**80061155-SBG-WOODG-NA-
RP-I-00001
CONTAMINATED LAND
PRELIMINARY RISK
ASSESSMENT ADDENDUM
WOODGATE HILL WTW
COMPOUND**

STRABAG UK LIMITED

Revision	Date of issue	Prepared by	Checked by	Approved by	Changes
P01	29/04/2026	AI	CT	CE	First Version
P02	05/05/2026	JM	CT	CE	Revision post comments
P03	11/06/26	CT	WH	CE	Revision post comments
P04	03/08/26	CT	WH	IM	Revision post BURY CLO Sally Shaw comments

Image 1 - Historic structure indicated 1888-1914

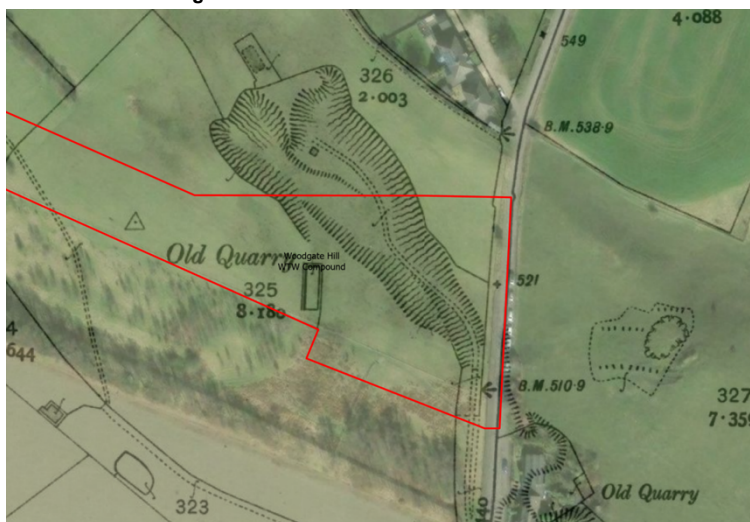
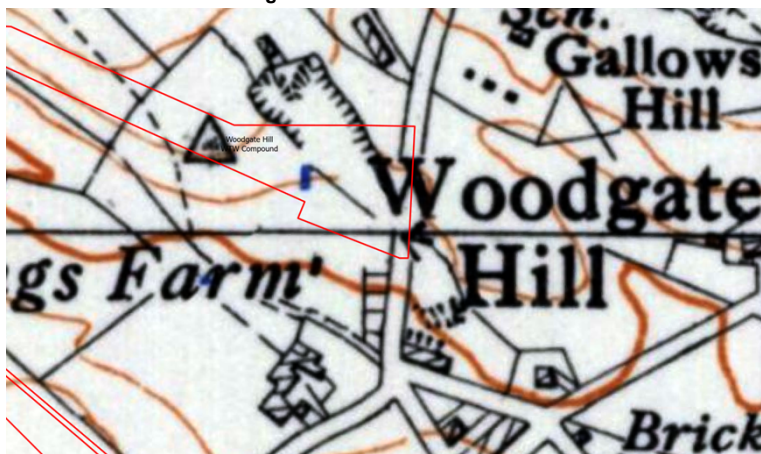
'The historic land use referred to as an animal pen from the undated historical map is shown to be a covered reservoir on mapping from c1937. Post war mapping of this area is incomplete, but we have reviewed aerial imagery. In c1940 the adjacent quarry depression and raised area of the reservoir is apparent. Aerial imagery from 1979 and subsequent imagery indicates that this land is now flat which indicates potential for infill. It is recommended that the applicant contacts this Section regarding obtaining the mapping and aerial imagery prior to planning and undertaking the proposed site investigation works in this area Once this information had been considered the consultant should advise whether one trial pit in this location is sufficient.'

An initial intrusive study was undertaken on 22/4/26 to identify the unknown feature present on historic mapping. The survey was undertaken post consultation with respect to archaeological conditions at the site, no features were identified and there was no requirement for a watching brief.

A trial trench was cut through the feature to 1.2m BGL to identify the structure and any contaminants present. Samples for WAC were undertaken, results are provided as **Attachment A**.

The structure comprised locally lined stone blocks at an average depth of 1.2m there were no contaminants present within or external to the structure. Surface infill comprised topsoil and subsoil with no odour or water observed. Images are provided below.

Figure 4 Historic trial pitting

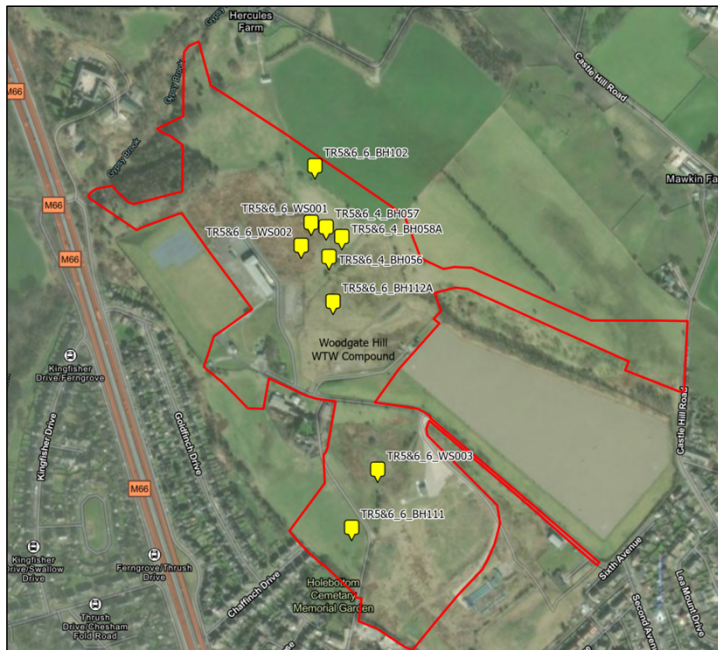
'This information should also be provided to inform the geo-environmental assessment. It is assumed that a watching brief for unexpected contamination will be carried out during these works.'

Historic trial pitting and boreholes was undertaken during 2021 for BHs 56, 57, 58A, 102, 111, 112A, WS001, WS002 and WS003 see **Figure 4** below. Borehole log information for surface profiles is found within **Table 6.1**.
